ODISHA BRIDGE & CONSTRUCTION CORPORATION LIMITED

Sub: Construction of Netaji Bus Terminus at Cuttack on Lumpsum Turnkey Basis - "Regarding Approval of Terminal Building South Side Façade Elevation".

With reference to the subject cited above, and in response to your Letter referenced "4", the South side facade elevation of the terminal building and façade views 1&2 are being accorded conditional approval with the following conditions:

SHEET NO: ARC/ ELV/ VIEW 02 00 WM O.B. & C.C. Let., **Bhubaneswar**

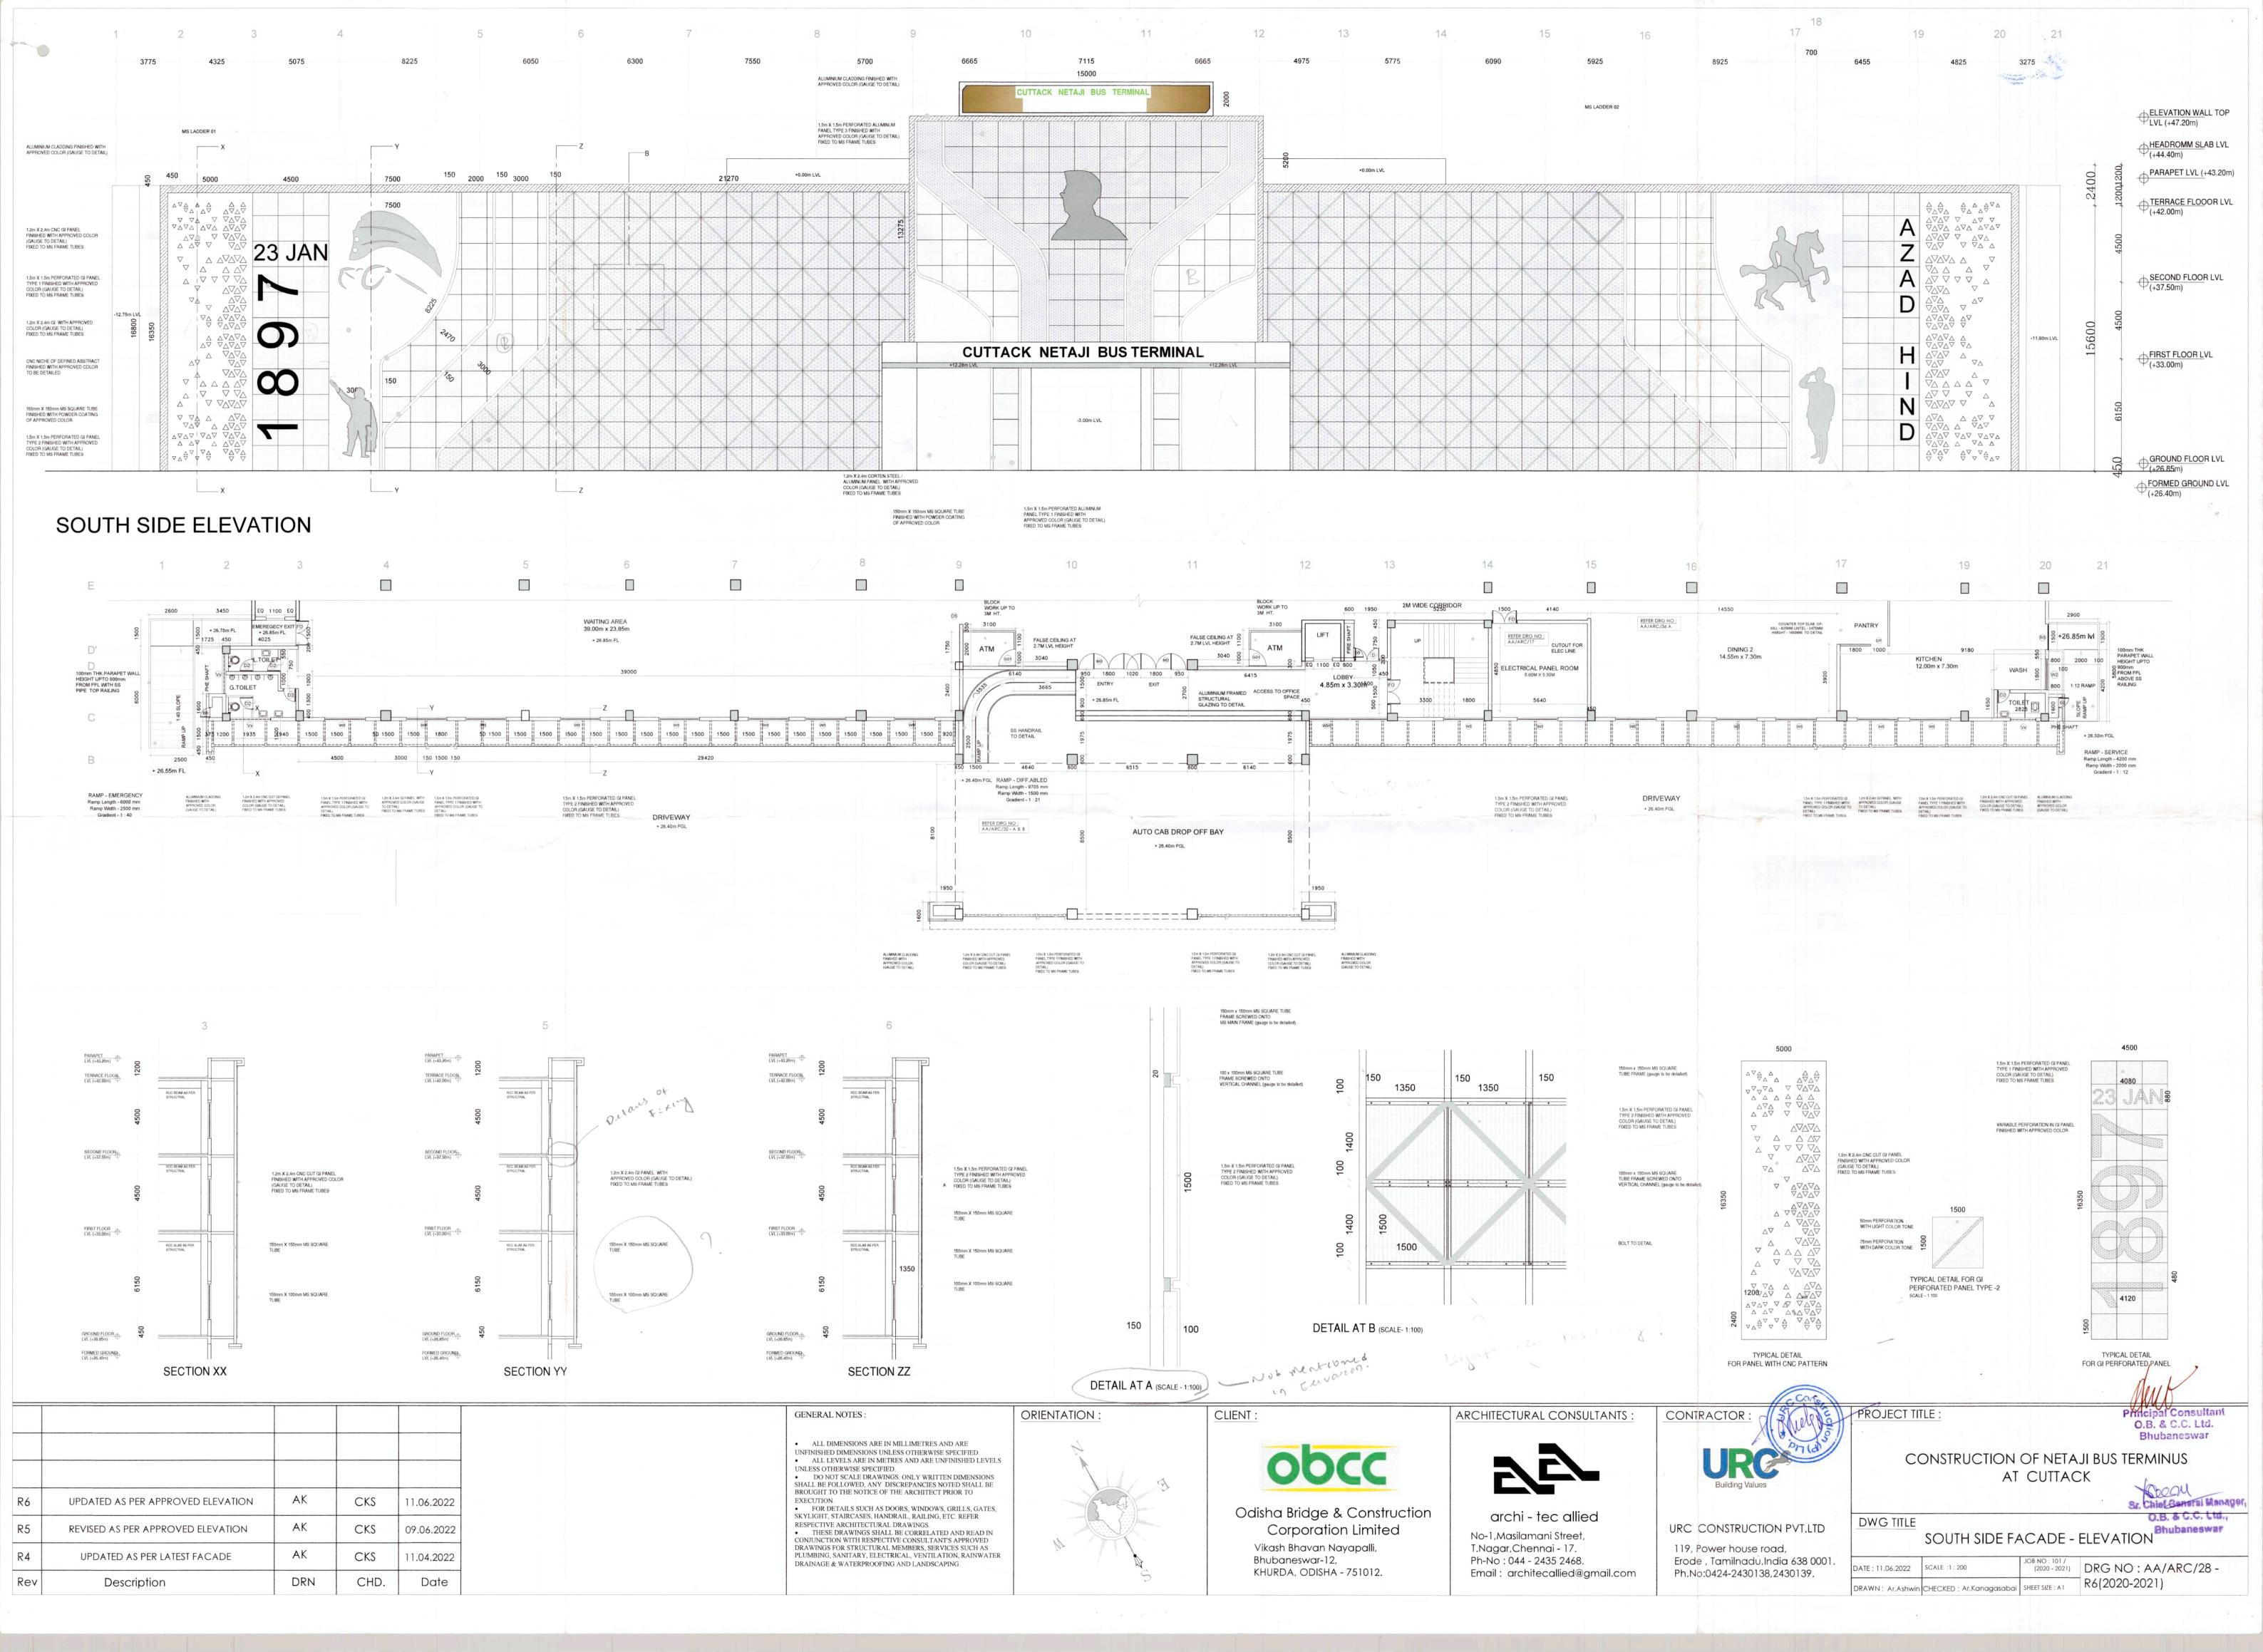
- 1. Powder coated aluminium panel should be used in place of perforated G.I. panels proposed in the facade. Refer "A" in the attached image.
- CNC Pattern Panel, Motifs and other areas shown in the attached image as "B" to be fabricated in Corten Steel.
- 3. Motif details with its measurements required to be submitted for review.
- 4. Façade lighting details must be submitted for review.

A - FABRICATION IN CORTEN STEEL

B - POWDER COATED ALUMINIUM PANEL
